From: Michael Webb
To: NORRIS, GREGORY P
Date: 1/29/04 7:59AM
Subject: Consultant's preliminary review of RBS request to use GOTHIC

RIVER BEND STATION
Docket 50-458
PM: Michael Webb

Preliminary Review of the RBS Request to Use GOTHIC 7 for Sub-compartment Analysis

Figure 1 Water mass rate and enthalpy profiles for the 8 inch RWCU break in the Filter/Demineralizer room.

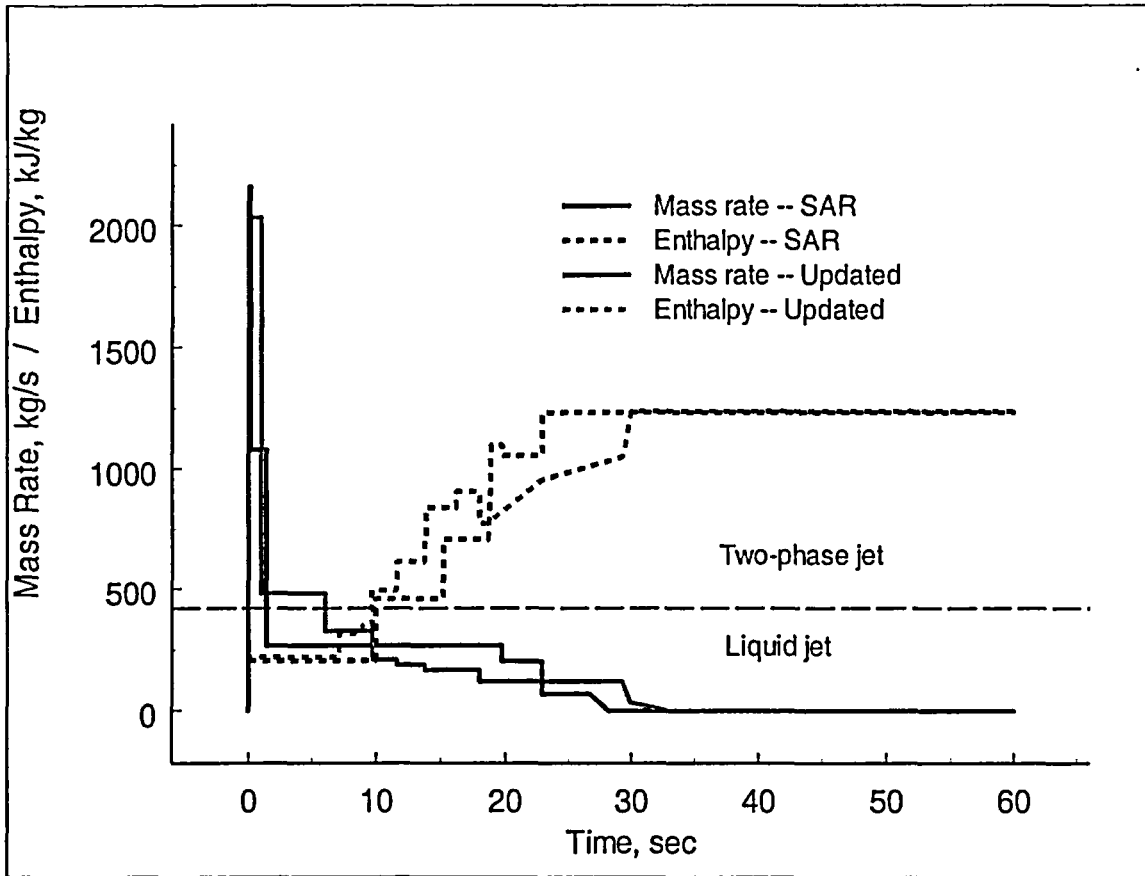
Since the 8-inch RWCU line break in the Filter/Demineralizer room represents a limiting case for sub-compartment analysis, this event is reviewed in some detail. Shown in Figure 5 is the mass rate and specific enthalpy profiles for the SAR and the new sources used for the updated SAR. The horizontal line that divides the two-phase and liquid jet regimes for the blowdown is based on the level of liquid enthalpy for flashing at atmospheric pressure. What this figure shows is that for the first ~ 10 seconds the break flow is liquid water that will not flash. The water is relatively cold and we would expect that most of water would go directly to the room sump. In fact, ~ 50% of the total water injected into the room is in the form of unflashed liquid during the first 10 seconds of the blowdown. Basically, this condition is identical for both the SAR and updated SAR sources.

Figure 2 Comparison of CONTAIN and THREED Filter/Demineralizer room sub-compartment pressure and differential profiles for 8 inch RWCU line break (100% entrainment of water injection).

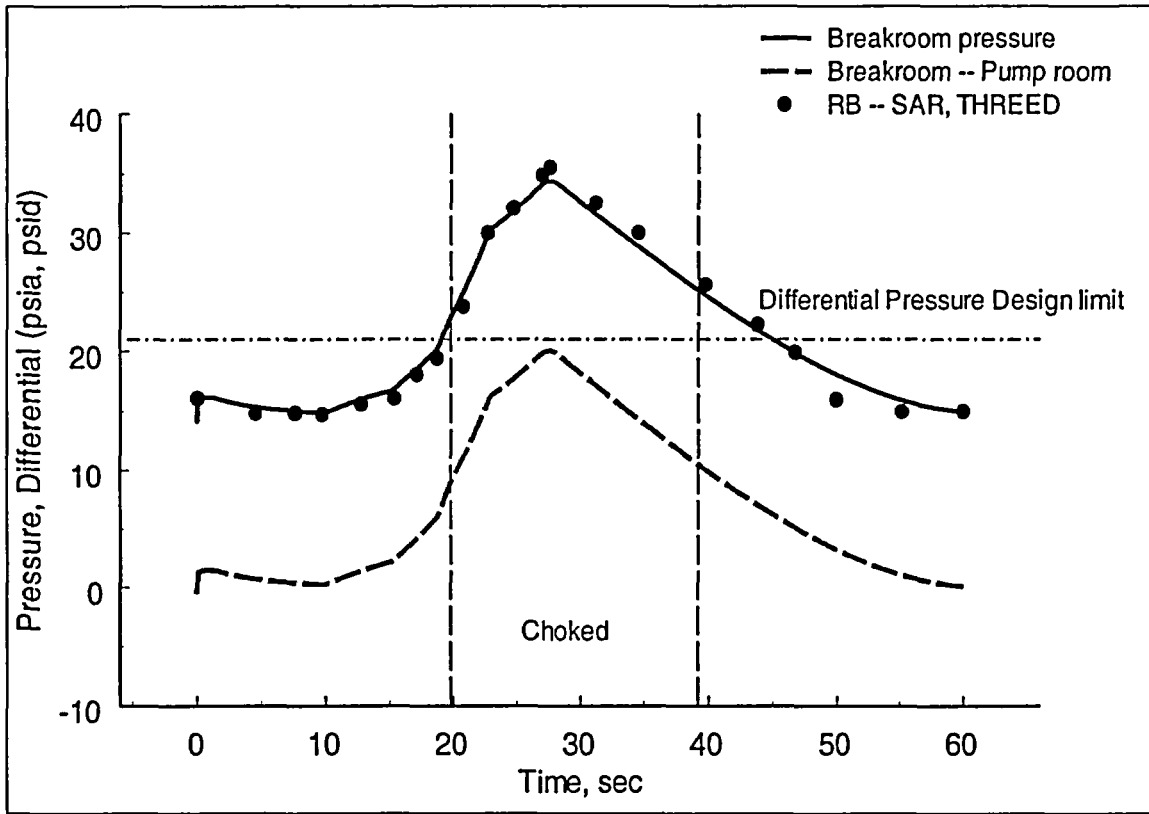
Guidance in SRP 6.2.1.2 specifically addresses only the conditions within the vent flows (homogeneous equilibrium model, with 100% entrainment). The guidance does not address conditions within the sub-compartment with respect to injected liquid water that becomes suspended. It has been past practice to consider 100% entrainment of injected water to maximize break compartment pressure for subsonic as well as supersonic flows. However, this practice is only empirically established for primary system line ruptures (HDR rupture line tests for PWRs / Waltz Mill tests for Ice condenser PWRs). Low pressure / temperature lines such as the RWCU lines should be considered a special case. Shown in Figure 6 is the break room pressure and pressure differential calculated with CONTAIN (homogeneous frozen model for critical flow, with 100% water entrainment within the break room and vent path). In this case, the homogeneous frozen model is multiplied by a factor to convert the critical flow model to a nonadiabatic, homogenous equilibrium model. The comparison with the THREEED calculation is good.

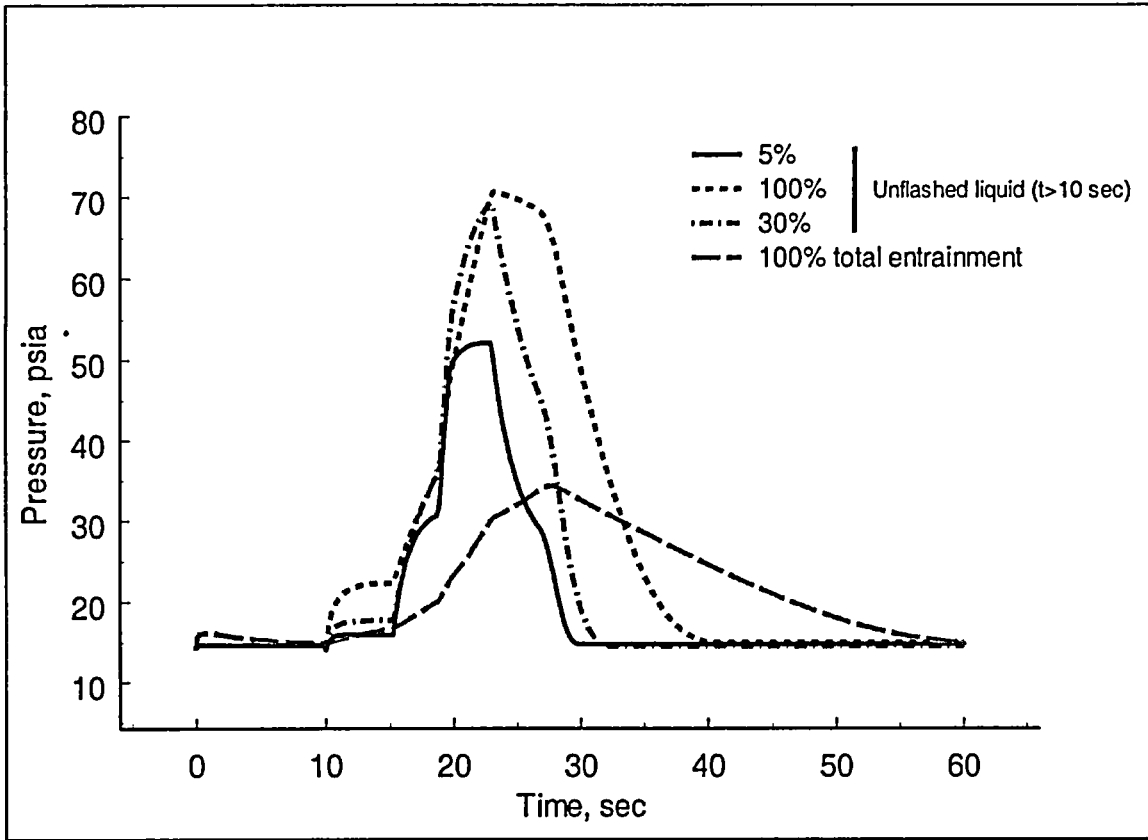
between the break and adjoining compartments. The thermal equilibrium effect is in part offset by the added resistance in the vent paths as a result of suspended liquid. It is not clear that an assumption of 100% entrainment will always result in the maximum pressure differential. For example, shown in Figure 7 are the pressure differential for the Filter/Demineralizer room assuming no entrainment of the initial liquid water ($t < 10$ seconds) followed by various assumed entrainment percentages of the unflashed liquid ($t > 10$ seconds). Clearly, the assumption of 100% entrainment (for liquid and flashed water) for this specific scenario is not the most conservative assumption for estimating safety margins.

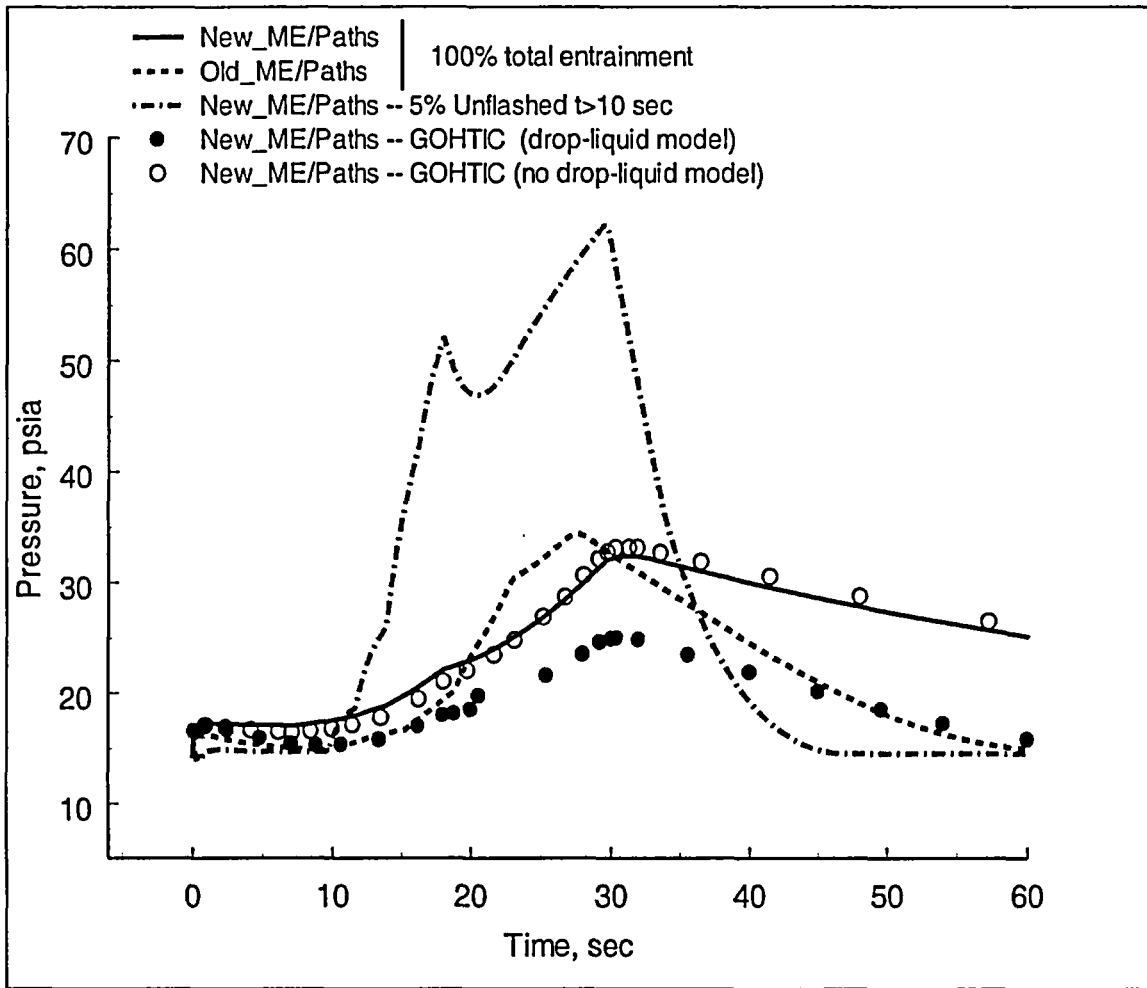
Shown in Figure 8 are the break room pressures for the new sources and new vent paths used in the updated SAR submittal. The assumptions that maximize the break room compartment pressure above for the original SAR mass and energy source (Old_ME/Paths) also apply for this case (New_ME/Paths). Because the Filter/Demineralizer room has been calculated with pressures that would exceed pressure differentials allowed by structure analysis, it is recommended that the RB analysis both from previous and current analysis be review indepth. Updated calculations by RBS show break room pressure and pressure differentials below the SAR values previously calculated with THREED. As indicated in Figure 8, the GOTHIC calculations without the drop-liquid conversion model are equivalent to the CONTAIN calculation with 100% total entrainment. The observation that the drop-liquid conversion model reduces the break room pressure below the case with partial entrainment suggests that the GOTHIC calculation with the drop-liquid conversion model includes an effect other than entrainment/de-entrainment. It is possible that the separate flow field equations are simulating significant slip between the fields in the vent paths. A simulation of nonhomogeneous flow in the vents needs validation.
